| Well Name: RODNEY ROBINSON FED COM | Well Location: T23S / R33E / SEC 7 / SESE / 32.3135917 / -103.6037167 | County or Parish/State: LEA / NM |

Notice of Intent

Sundry ID: 2666404

Type of Action: APD Change

WELL LOCATION AND ACREAGE DEDICATION PLAT

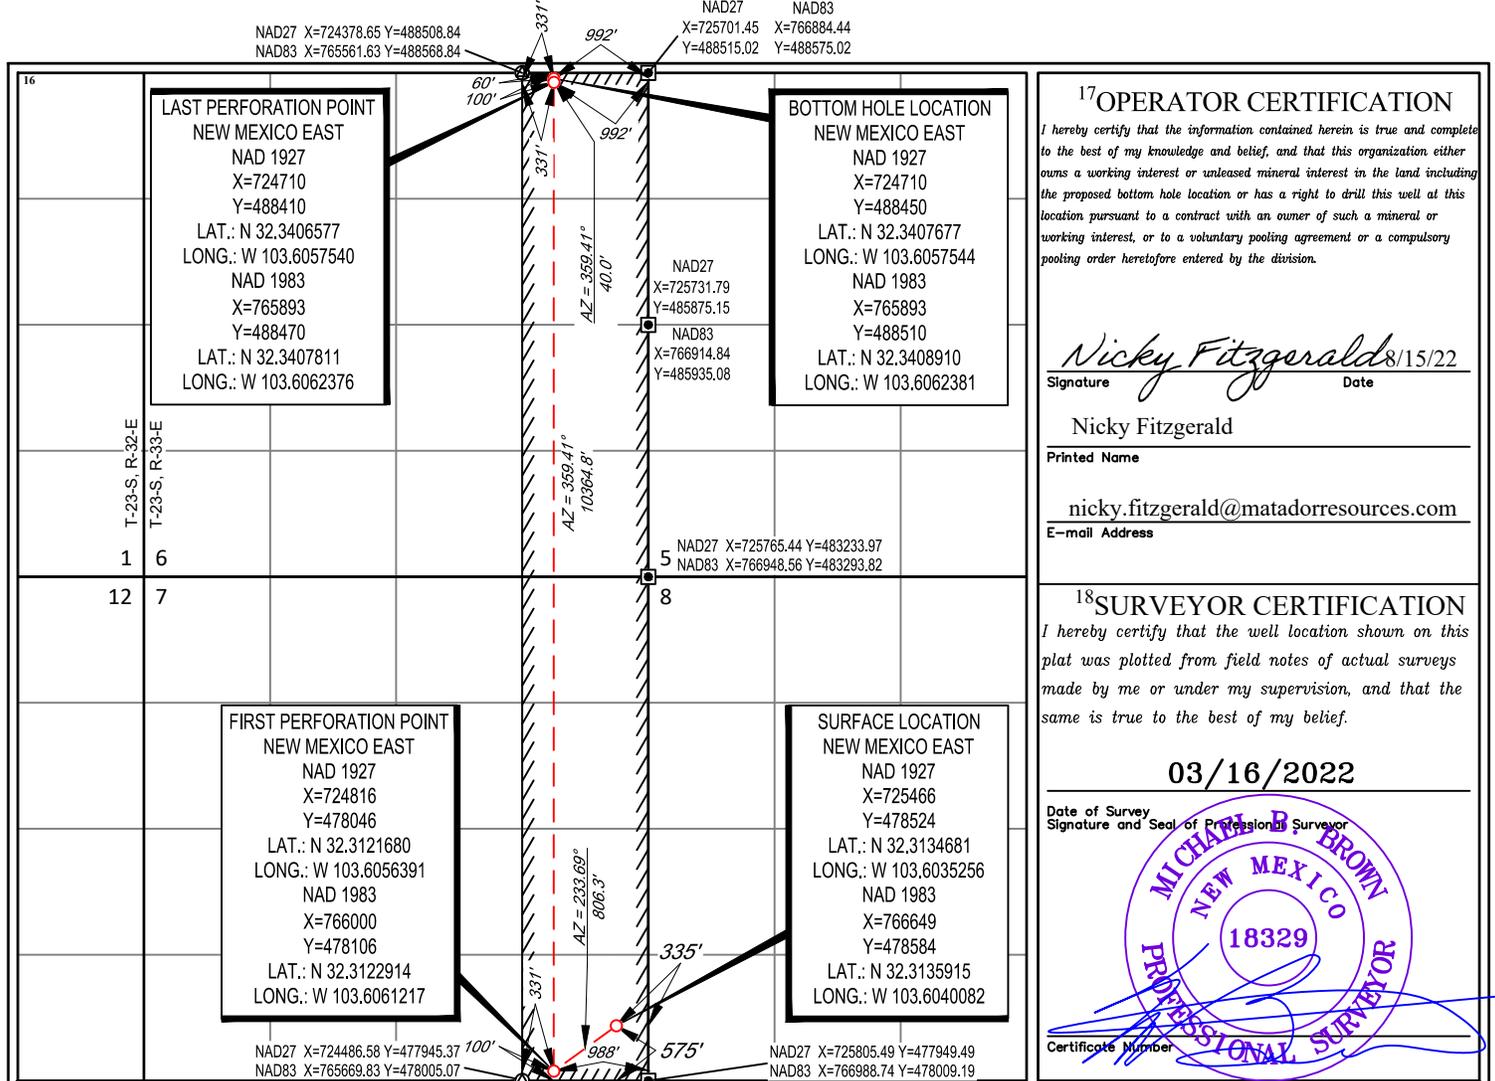
Procedure Description: BLM Bond No. NMB 001079 Surety Bond No. RLB 0015172 Matador respectfully request the option to make the following changes to the Rodney Robinson Federal #024H: - Change the SHL from 576' FSL & 245' FEL to 575' FSL & 335' FEL. SHL remains on previously approved pad site. - Change the BHL from 60' FNL & 330' FEL to 60' FNL & 992' FEL. BHL remains in the previously approved unit. - Deepen well to 2nd Bone Spring, attached is revised drill plan with updated casing depths Thanks for your time and diligence on this matter.

| UL or lot no. | Section | Township | Range | Lot Idn | Feet from the | North/South line | Feet from the | East/West line | County |
|---------------|---------|----------|-------|---------|---------------|------------------|---------------|----------------|--------|
| P | 7 | 23-S | 33-E | - | 575' | SOUTH | 335' | EAST | LEA |

| UL or lot no. | Section | Township | Range | Lot Idn | Feet from the | North/South line | Feet from the | East/West line | County |
|---------------|---------|----------|-------|---------|---------------|------------------|---------------|----------------|--------|
| 1 | 6 | 23-S | 33-E | - | 60' | NORTH | 992' | EAST | LEA |
